**MEMORANDUM
RE: ADDITIONAL DOCUMENTATION**

PROPOSAL: Hawaii Kai Multi-Family
CU2019-0001 / DR2019-0012 / LD2019-0003 / PLA2020-0001 / TP2019-0001

LOCATION: 4500 and 4550 SW 96th Avenue.

GRADING

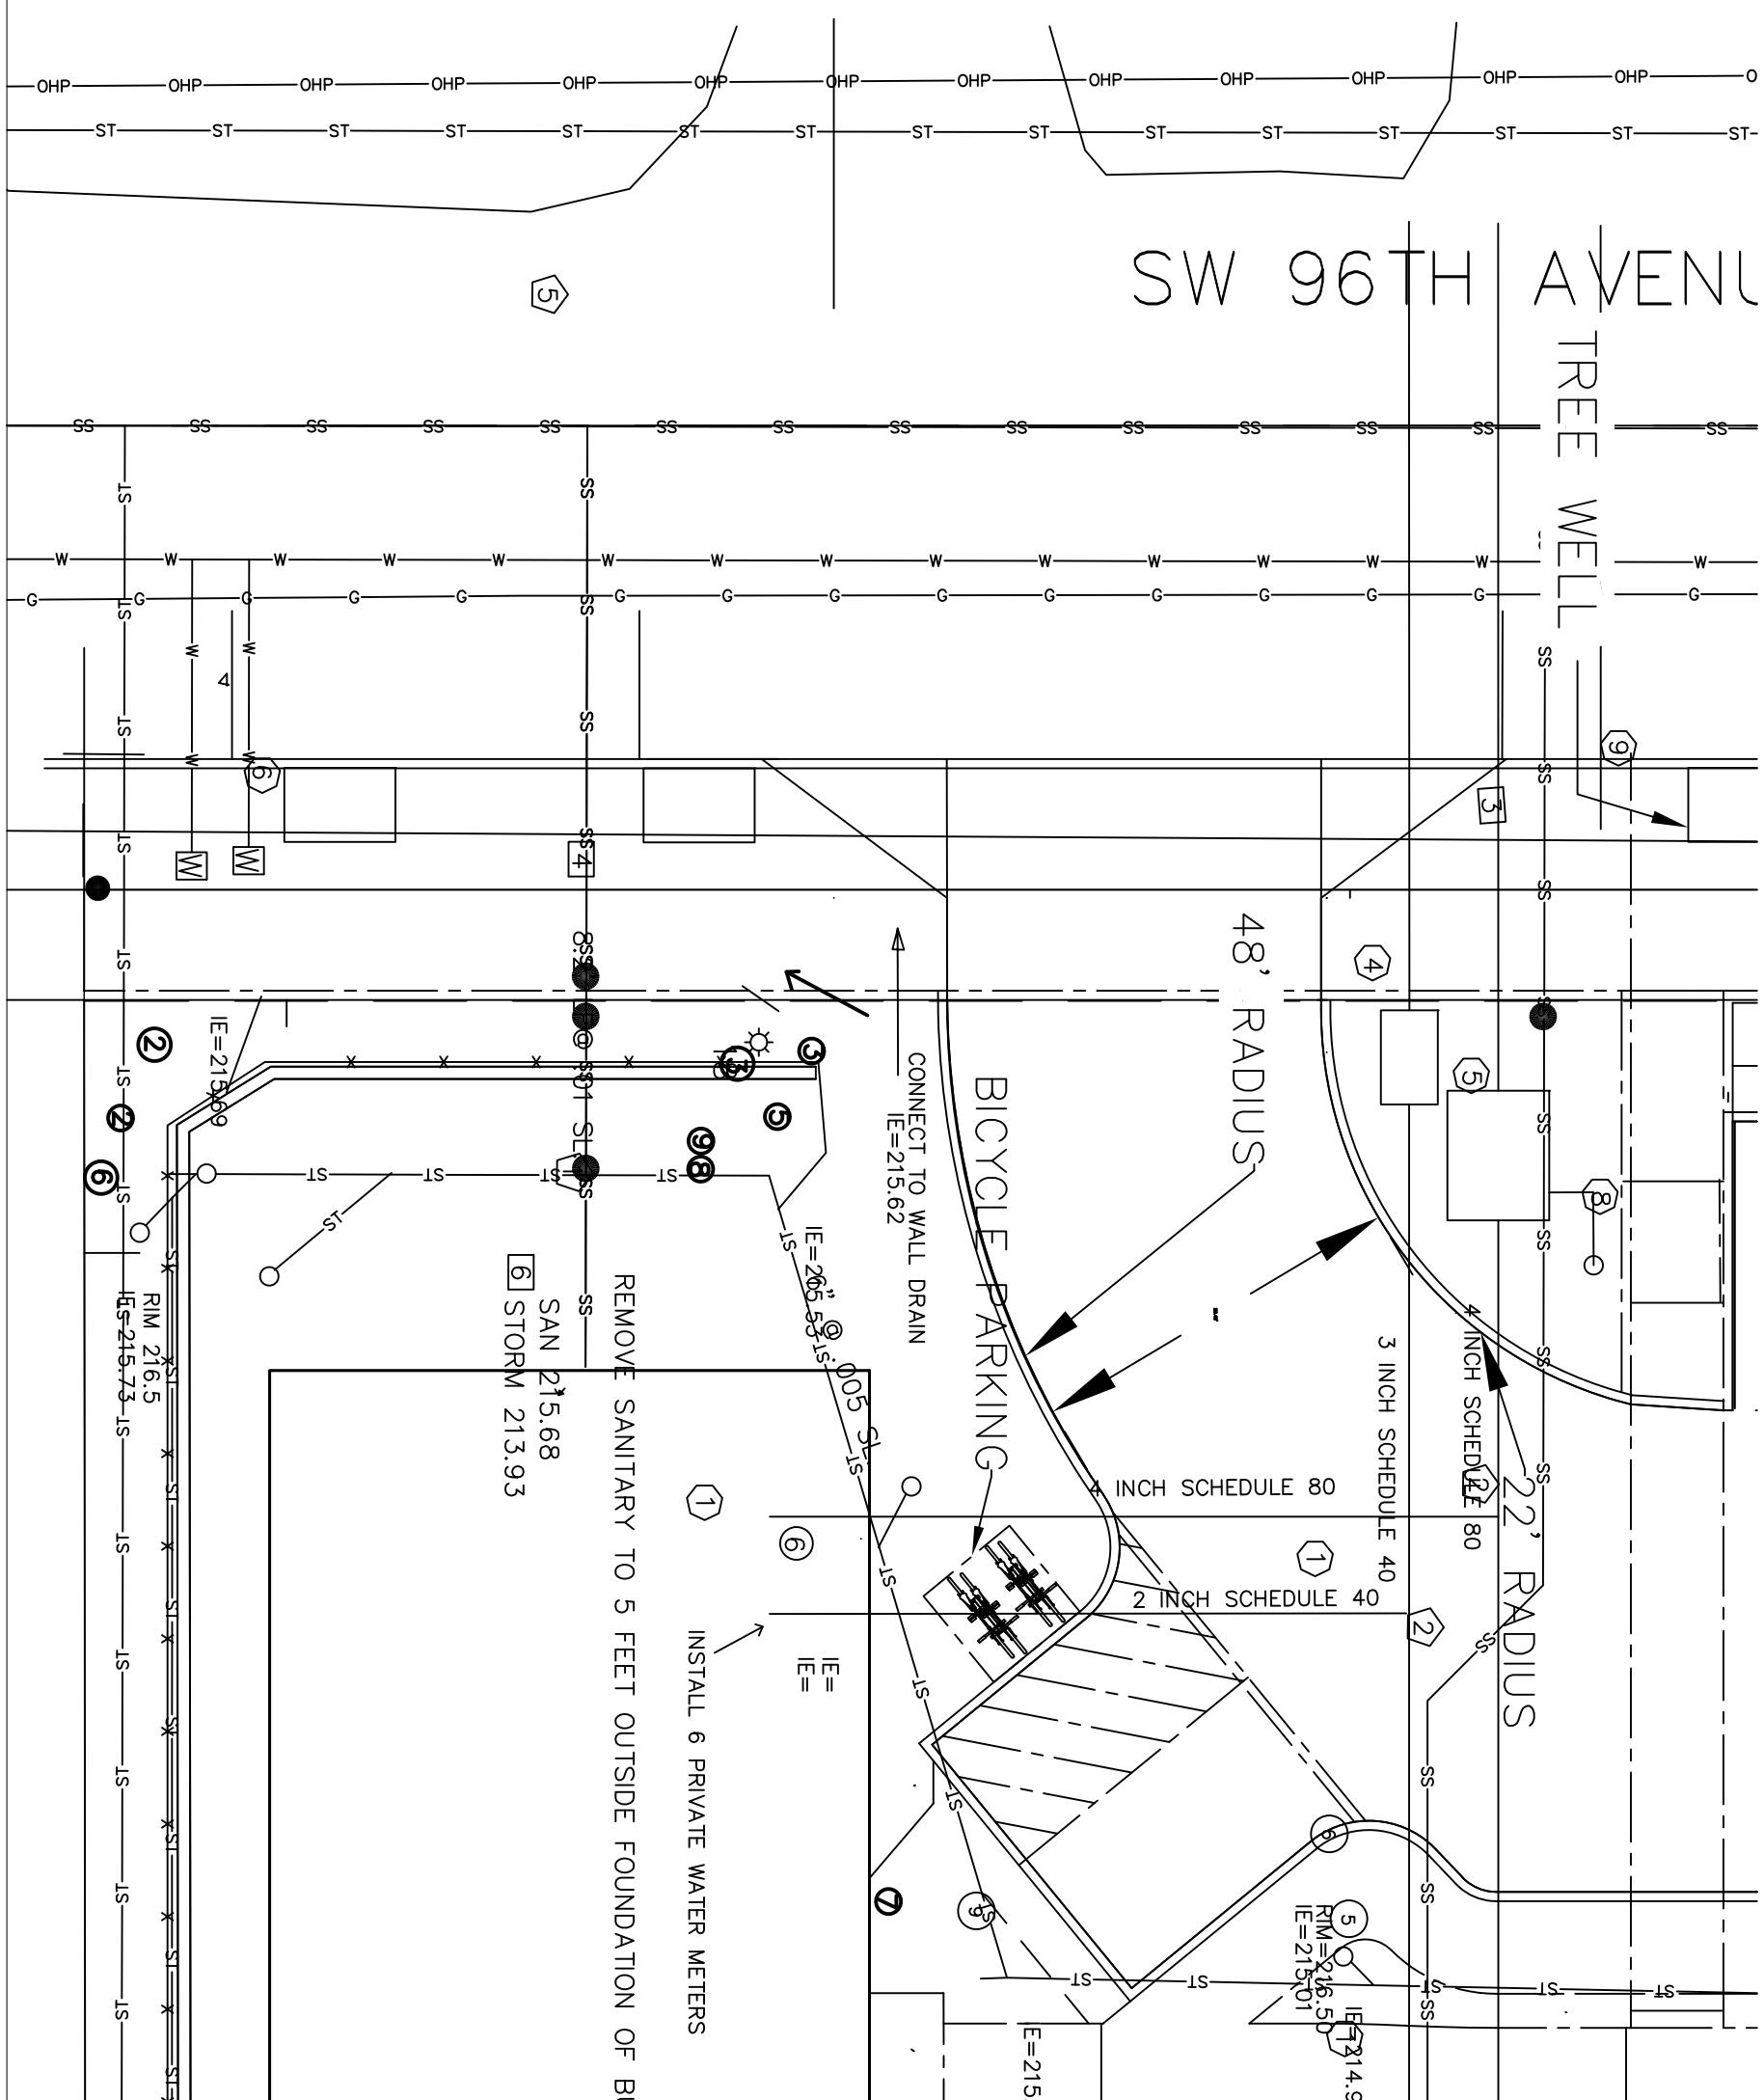
The applicant's grading plan is difficult to read and therefore compliance with Facilities Review criterion J and other grading standards cannot be determined. Without the ability to determine if the proposed grading complies with Development Code standards, affirmative findings cannot be made.

60.05.25.10 Minimize grade changes	The applicant's grading plan is difficult to read, only the 220 contour line is labeled, existing and proposed grading are not labeled in the legend or on the plan, and it is unclear how the proposed walls and	No

RESPONSE: Applicant has submitted a revised Grading plan that is easier to read and meets the requirements of Facilities review criterion J and other grading standards. See also the changes made to the Chapter 20 Facilities Review Narrative which sets forth detailed explanations of the grading, etc. changes made to meet compliance.

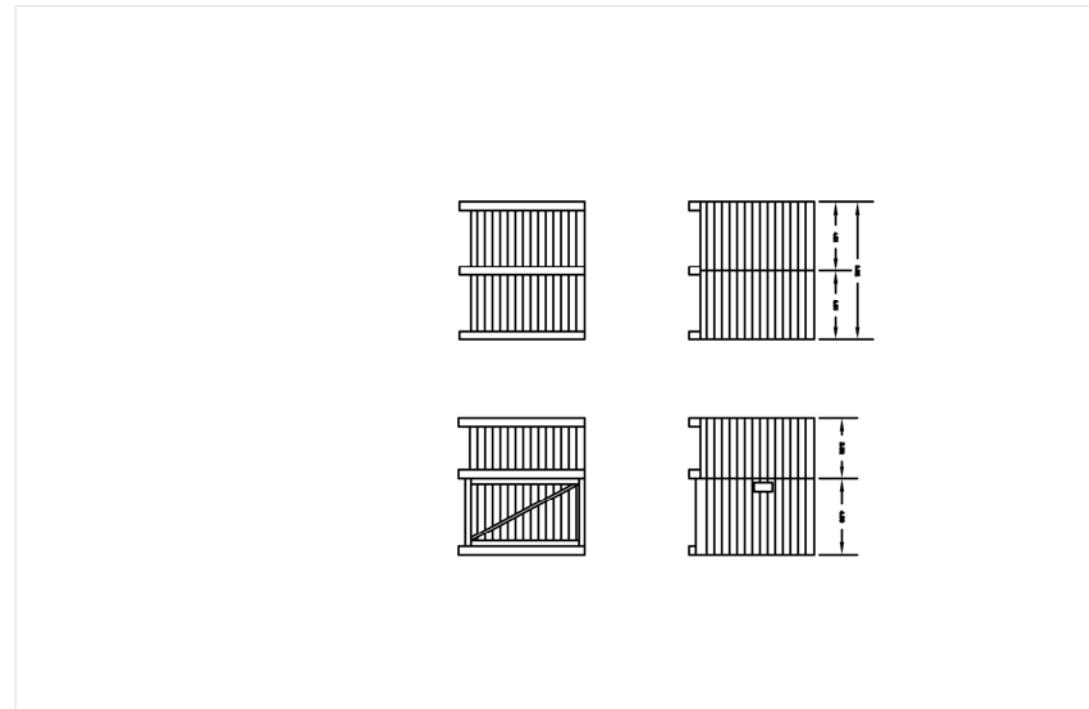
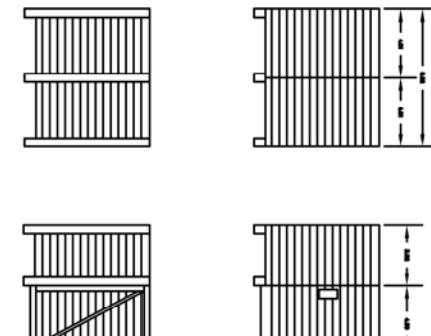
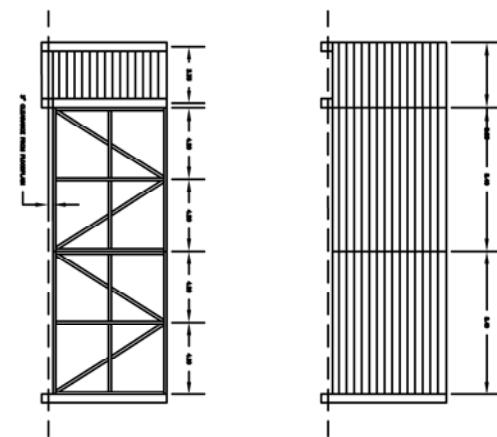
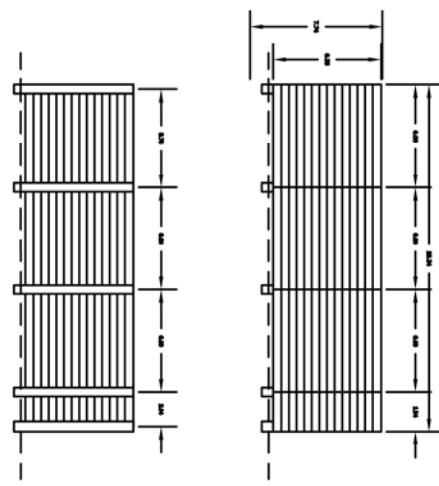
Loading Areas, solid waste facilities and similar improvements		
60.05.20.2.A-D Screen from public view	The applicant states that the waste storage and recycling containers are enclosed with Hardie plank siding and wood gate to match building. The applicant also explains that screening shall be one foot higher than the object being screened. However, the applicant's materials do not include elevations or dimensions of the proposed enclosure therefore staff is unable to determine compliance with dimensional requirements or design elements. The applicant further states that a transformer and above ground utility services shall be screened and shown on construction drawings to keep from view from the public street. However, staff is unable to determine where above ground utilities are located or how they are to be screened. RESPONSE: The necessary changes have been put on the Landscape Plan.	No RESPONSE: Landscape Plan and Site Plan revised to meet requirements. Slider door elevation and materials provided
